SEPTITECH, INC.

Subject: Approval, Revised Product Registration, SeptiTech Porous Drip Hose System

SeptiTech Seasonal Shallow Drip Hose Disposal Area Profile

Subject: Approval in Part, Denial in Part, Product Registration, SeptiTech Combination UV Drip Hose System

REQUIREMENTS
 Full (Upslope)
 Full (downslope)
 (Min 12" depth to limiting factor is met) Page 3 of 4

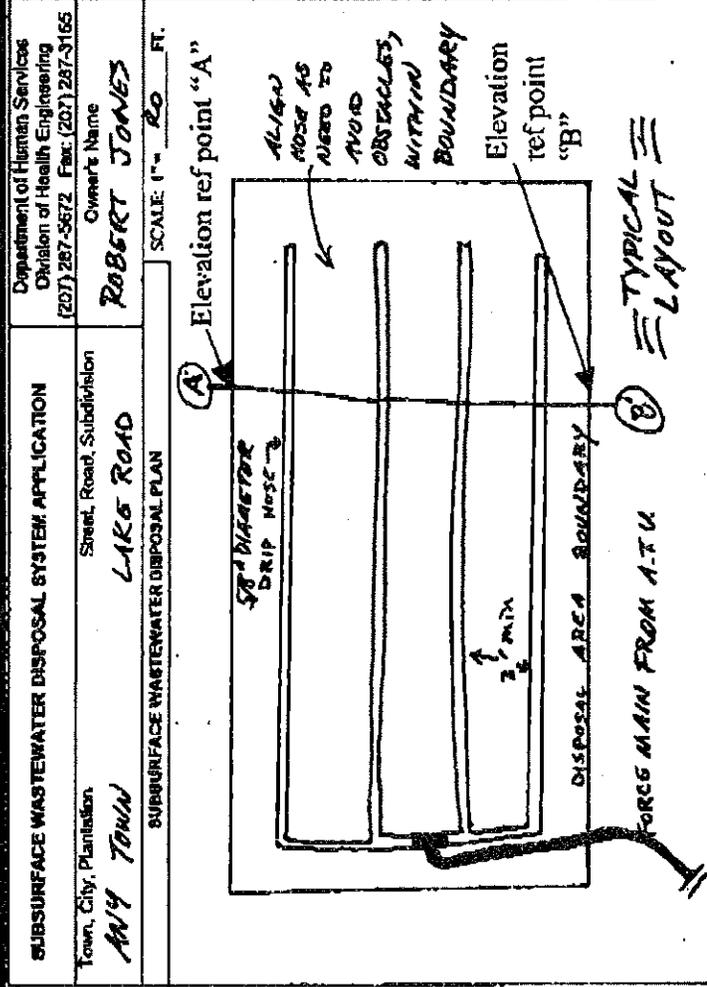
As Jim Jacobsen briefed you before his vacation, this slide represents a slight modification to Jim's MASE drip hose presentation slide #7. The key difference is that it shows how to use elevations with the drip hose disposal system, whereby elevations relate to the disposal area boundary and not individual hose runs.

- E Page 3 should show typical hose layout
- E It is understood that hoses may be irregularly placed to accommodate obstacles
- E Elevations relate to high and low points of disposal area boundary only, not individual hose runs. (Maximum 10-ft. differential between high and low points).

I'm sorry that this took so much longer than it should have. The minor change to the PowerPoint show, indicating that elevations are measured to the boundary area, is fine.

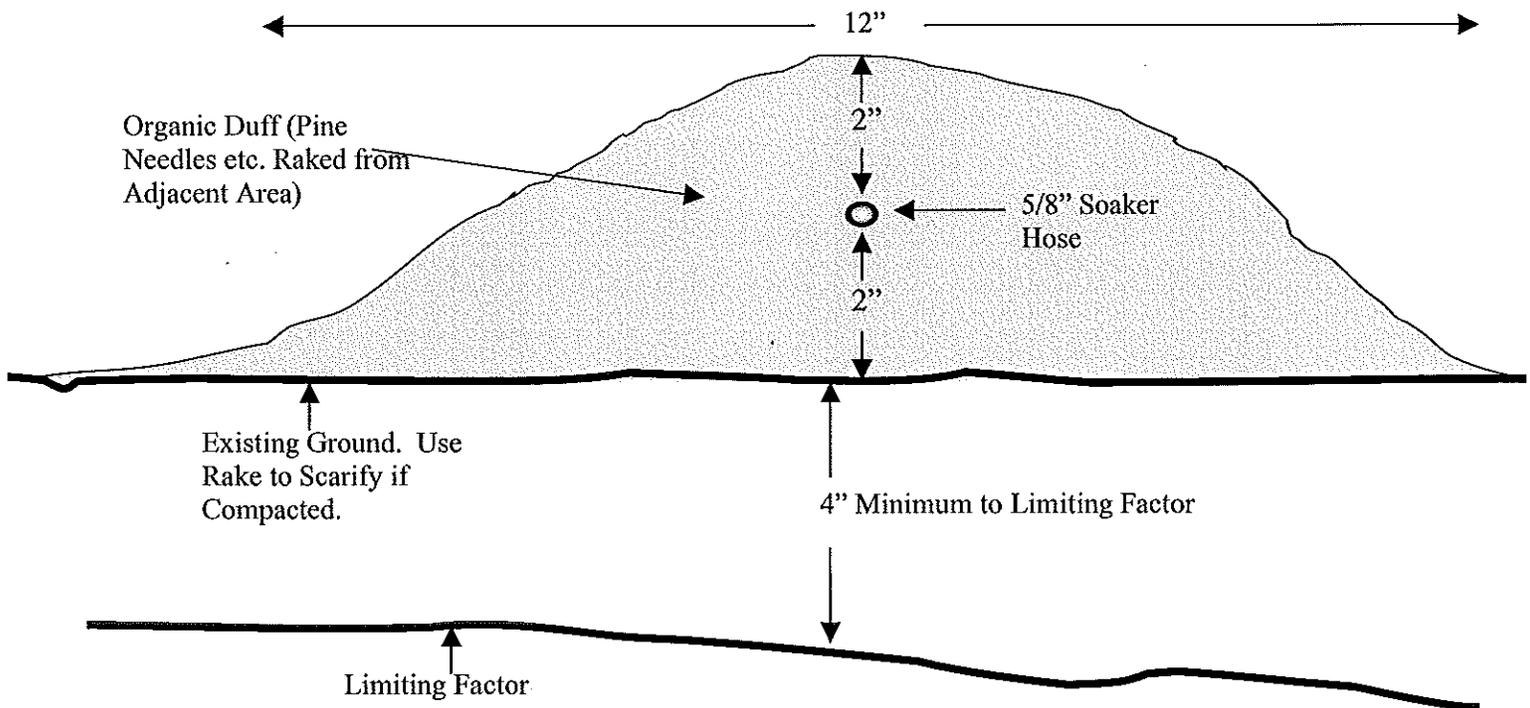
Therefore, by this letter I would like to request an amendment to our seasonal drip hose approval specifications to a minimum of 4" of mineral soil and a minimum separation distance of 6" to refusal (on replacement systems only) as depicted on the enclosed sketch. This request is made for the following reasons.

Rationale for proposed modification #2: with a minimum separation distance of 4-inches maintained between the seasonal high groundwater table or other limiting factor:

This change, applicable to replacement systems, is more for clarification because during the experimental phase all the systems were installed in this manner, with near surface application. It reflects actual conditions on sites where drip hose is typically specified. A typical site for this system generally has minimal native soil and very small distance to limiting factor. For instance, throughout MacMahan Island, and most coastal properties the average distance to limiting factor is 6-inches or less.

The SeptiTech porous hose system shall be separated by a minimum of 12 inches from bedrock and the limiting factor, which ever is found at the higher elevation. The Division finds no compelling justification for reducing the separation distance to less than 12 inches, particularly the normal 24 inch separation from bedrock.
